## Memorandum City of Lawrence Planning & Development Services

то:	Lawrence Douglas County Planning Commission
FROM:	Sandra Day, AICP, Planner II
CC:	Scott McCullough, Director of Planning and Development Services
Date:	November 8, 2013
RE:	PP-13-00338; Preliminary Plat for Menards revised submittal

## NO. 3C PRELIMINARY PLAT FOR MENARDS ADDITION; 1900 W 31<sup>ST</sup> ST & 1352 N 1300 RD (SLD)

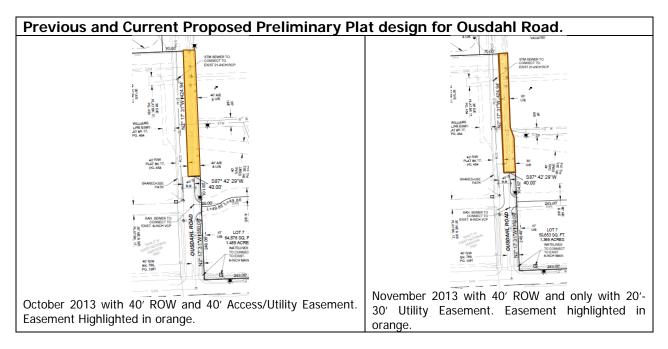
The October 2013 plat proposed to complete Ousdahl Road to the north lot line of the adjacent property with a 40' access/utility easement adjacent to the existing right-of-way platted with the final Plat of First National Addition. Staff's recommendation was that Ousdahl Road should be developed as a full width local street (30' of Right-of-way each side). Refer to October Staff Report for recommendation.

The most recent submission reverts to the one-half right-of-way with only a 20' utility easement proposed to be dedicated on the east side of the street centerline. This current configuration leaves a half street with no development potential for the abutting property to the west. Section 20-810 (e) (9) requires dedication of the remaining one-half of a street. This section specifically states:

Staff recommends the preliminary plat be revised to show a complete street right-of-way per the subdivision regulation requirements noted above.

**Staff recommends** the dedication of 30' of right-of-way east of the centerline of Ousdahl Road extended north to match the existing right-of-way. Additionally the street will need to terminate in a cul-de-sac per section 20-810 (e)(2)(vi).

**Staff recommends** dedication of right-of-way for the termination of Ousdahl Road to accommodate either a hammerhead or cul-de-sac.

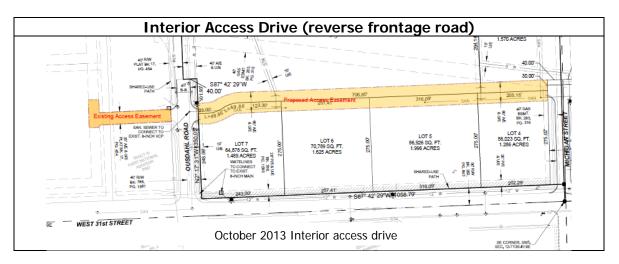
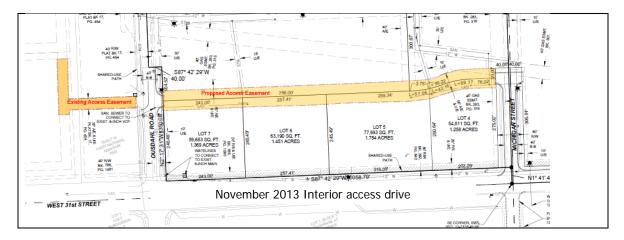
The proposed subdivision modifies the interior access drive along the north side of the pad sites (Lots 4-7) resulting in lot depth reduction from the originally proposed 275' to the current 245'. Both plat documents maintain the intersection connectivity with the existing access easements to the west. The alignment changes at the intersection with Michigan Street in the revised version. This access easement aligns with the west portion of the hammerhead that terminates Michigan Street within the subdivision.

The location of the interior drive, parallel to W. 31<sup>st</sup> Street, serves as a reverse frontage road providing access to all lots within the proposed development. The proposed access drive is aligned such that it creates a 4-way intersection north of 31<sup>st</sup> Street with the existing access drive to the west for the development within the First National Addition subdivision. The following images show the previous and current proposed alignment of the interior access drive.

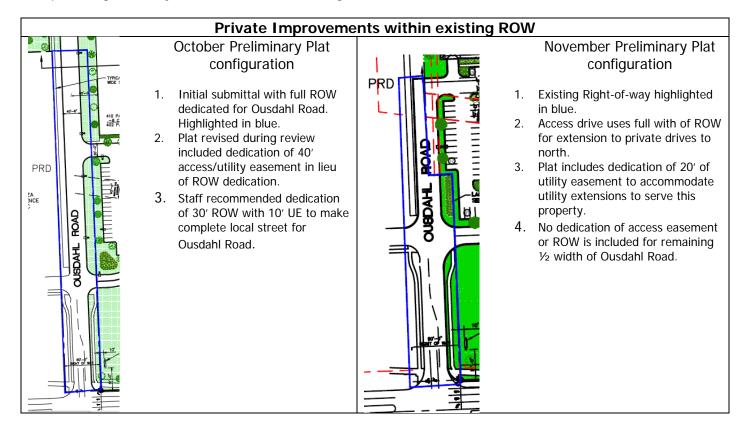
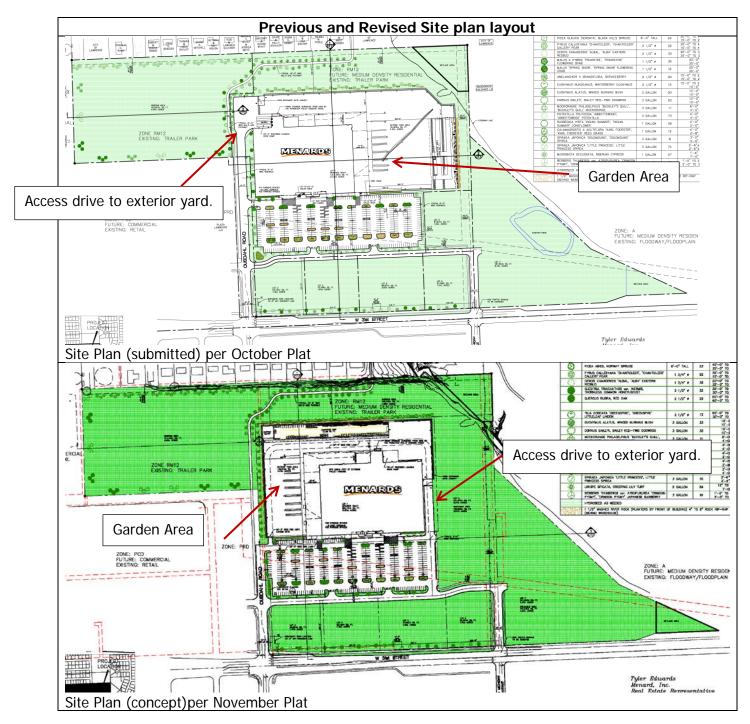
The significant impact of the combined changes to Ousdahl Road, the interior access drive, and the creation of Lot 2 is the ultimate configuration for site development of the Menards Lot. The October version of the preliminary plat provided the development of a Menards store with direct vehicular access to the exterior storage area for both customers and delivery vehicles along Ousdahl Road. Both subdivision plats include private improvements that are partially within the public right-of-way of Ousdahl Road (existing dedicated ½ ROW west of centerline).

The applicant has indicated a desire to flip the site layout and reduce the size of the exterior storage area for the Menards store causing a change to the preliminary plat (abandonment of Ousdahl Road and an increase in Lot 2). The revised site plan concept moves access to the exterior storage yard to the east. The applicant indicates that this design separates the garden area (typically frequented by pedestrians) on the west side of the building from vehicular and

truck access on the east side. The submitted site plan also separates the access drive to the rear of the store (on the west side) from the garden center (on the east side) but located the warehouse in such a way as to be across from the garden area (on the east side) which typically is accessed only by staff and vehicular traffic. These changes to the physical layout of the site impact how the property is subdivided.

Staff supports a recommendation for approval of the preliminary plat with a revised drawing that shows the dedication of right-of-way for Ousdahl Road per City street standards for width (minimum 60') and an appropriate street termination.

Attachment D.

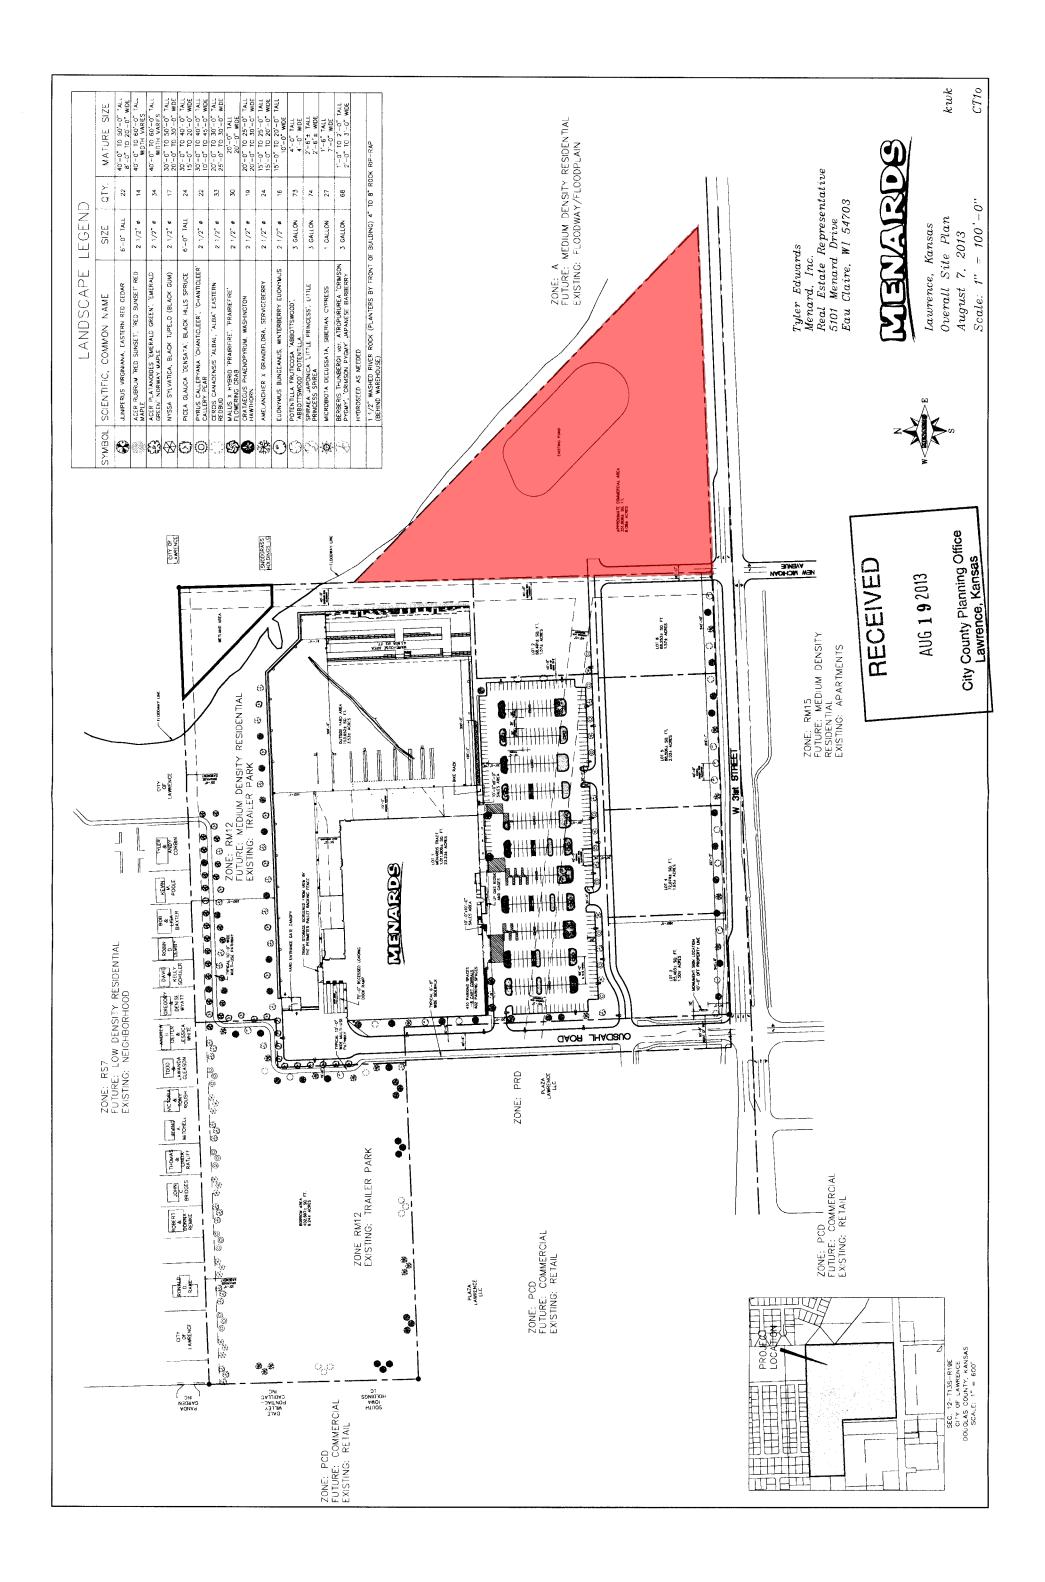
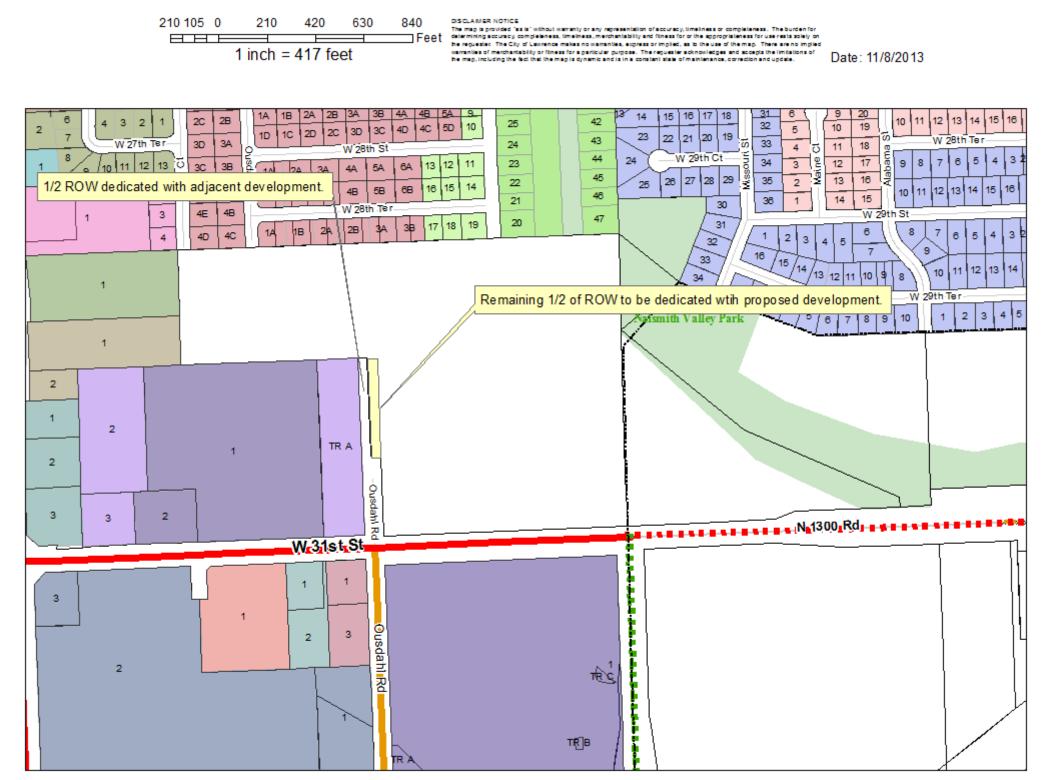
The proposed preliminary plat terminates the extension of Ousdahl Road leaving it with only  $\frac{1}{2}$  of existing right-of-way (along the west side of the centerline). Refer to Attachment D.

Figure 1: Existing and Proposed Access

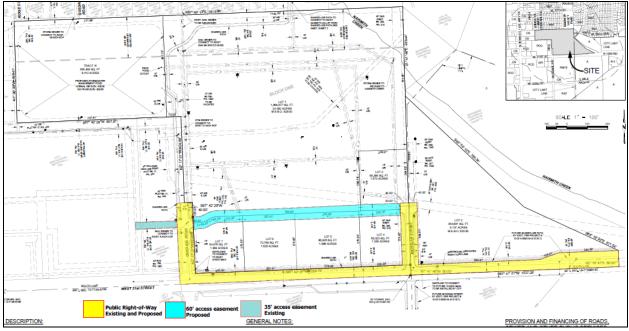
The graphic above highlights the existing and proposed right-of-way that will serve this development.

Ousdahl Road at W 31<sup>st</sup> Street includes 80' of right-of-way. While 80' wide, it is classiffied as a local street. Local streets typically only have 60' of right-of-way. This additional width accommodates turn lanes at the intersection. Farther to the north, Ousdahl Road includes only one half of the right-of-way (the west half) dedicated with a Final Plat of First National Addition. The expectation was that the east half of the right-of-way would be dedicated by the property owner upon development of what is today the Menards project.

The Menards Preliminary Plat was orignally submitted with 40' of right-of-way (east half) for Ousdahl Road. During the reivew process it was expressed by staff that this street serves only one development/property. Staff commented that the right-of-way would not be necessary and that the burden of long term maintenace should be the property owners'.

Late in the review process a representative for First National Addition contacted staff to discuss development options for property on the west side of Ousdahl Road. Pending other land use reivew and approval, access to Ousdahl Road extended would be desirable and potentially serve more than just one property. To protect the interests of both property owners, staff is recommending that the applicant for Menards proceed with the dedication of additional right-of-way. Right of way recommended is 30' (one half of a local street) with an adjacent 10' of easement for utilities.

1. Provision of a revised preliminary plat to show a dedication of an additional 30' of right-ofway and 10' of adjacent easement for Ousdahl Road extended north.
